# UNITED STATES PATENT AND TRADEMARK OFFICE

APPLICATION NO.	FILING DATE	FIRST NAMED INVENTOR	ATTORNEY DOCKET NO.	CONFIRMATION NO.
09/622,089	08/10/2000	Hiroki Nomoto	490042-87GS0	6664

## Office Action Summary

**DETAILED ACTION**

Note the bed heights of Moss figure 1 below as annotated by the examiner.

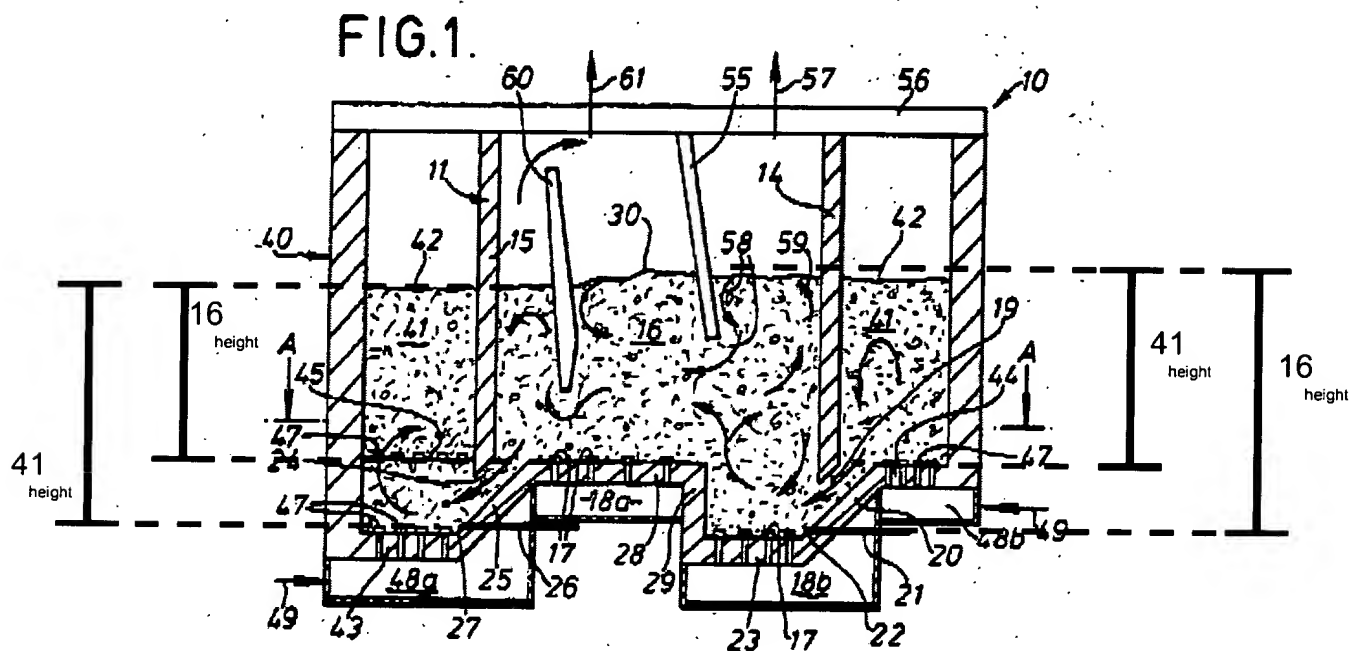
Applicant argues that Moss does not disclose wherein the connecting hole does not cause back mixing by a difference in a fluidized bed height from an upstream side to a downstream side.

The examiner respectfully disagrees. First, Moss does not explicitly state (and applicant has not pointed out where in Moss it is stated) that back mixing occurs or could occur. Second, even though the Moss states that the bed above the ramp/connecting hole results in flow of material down the ramp to the next compartment

the device, Moss also illustrates wherein the bed heights are different downstream and upstream of the connecting hole.

As annotated above, on the left side of the figure, upstream 16 is a different height than downstream 41 and on the right side of the figure, upstream 41 is a different height than the downstream 16.

The bed heights, in addition to the ramp/connecting hole, would impart some sort of effect upon the flow of material whether is it explicitly stated by Moss or not.

Since the apparatus of Moss continues to meet all of the structural limitations of the claims the rejection is maintained.
